Access Report

Project Description: To accompany a detailed State Significant Development Application (SSDA) for a shop top housing development at 362-374 & 376-384 Oxford Street, Bondi Junction. The site is made up of seven lots.

Ref: NSW210266

Report Type: Review for SSDA; - BCA Access Provisions

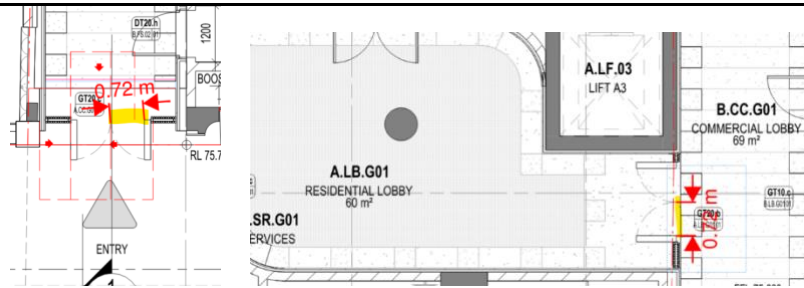
<p>D3D22</p>	<p>All fire stairs require a single handrail.</p> <p>All non fire-isolated stairs and ramps require double handrails in accordance with AS 1428.1</p> <p>To be incorporated prior to CC.</p> <p><u>Level 1 and 2</u> The size of the warning indicators near the spiral stairs doesn't comply. Tactiles to have 600 to 800 m unless there is a wall within 3m. To be in accordance with AS1428.4.1 (Figure 2.2(B)).</p>  <p>Redesigning for further assessment.</p>
<p>D4D2</p>	<p>All double doors to common areas require a single opening of 850mm</p> <p>Redesign</p> <p><u>Basement 1</u> A single opening of 850mm doesn't comply., gradient of no more than 1 in 40 is allowed withing door circulation</p>  <p><u>Ground floor</u> A single opening of 850mm doesn't comply.</p>

Redesign for further assessment.

Basement 1

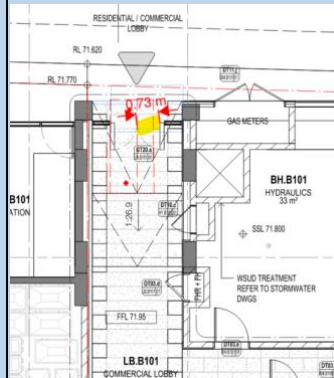
All double doors to common areas require a single opening of 850mm
Redesign

A single opening of 850mm doesn't comply.

Redesign for further assessment.

Ground floor

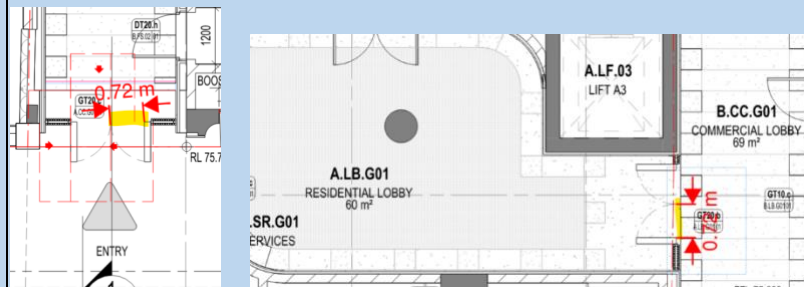
A single opening of 850mm doesn't comply.

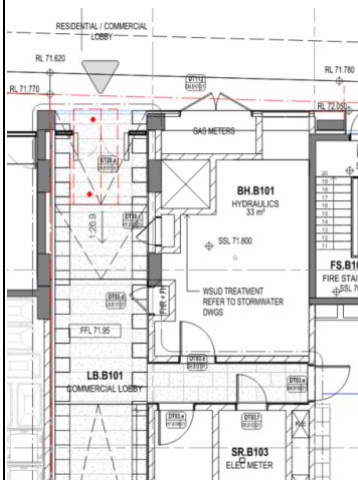
Turning circles have been provided to the end of corridors.

Please confirm gradient to lobby on B1 ramp at lobby door.

Landing is required between the ramps.
To be in accordance with AS1428.1.

Redesign for further assessment.

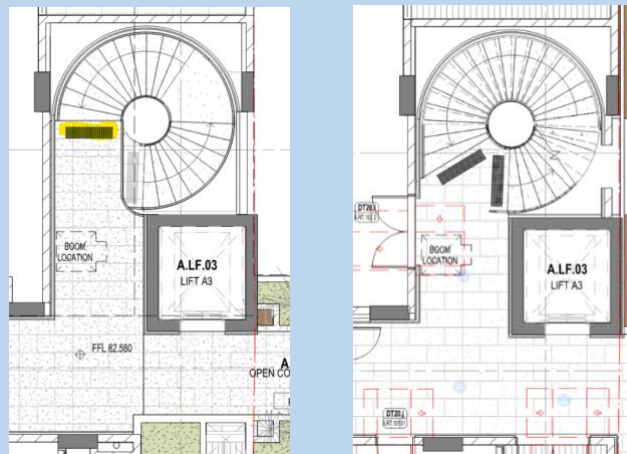
Tactiles required to the top and bottom of all stairs and ramps unless fire-isolated and to be in accordance with AS 1428.1.4 and AS 1428.1.

Stairs on GF require tactiles to the top and bottom

The size of the warning indicators near the spiral stairs doesn't comply. Tactiles to have 600 to 800 mm.

To be in accordance with AS1428.4.1 (Figure 2.2(B)).

To be incorporated prior to CC

Redesign for further assessment.
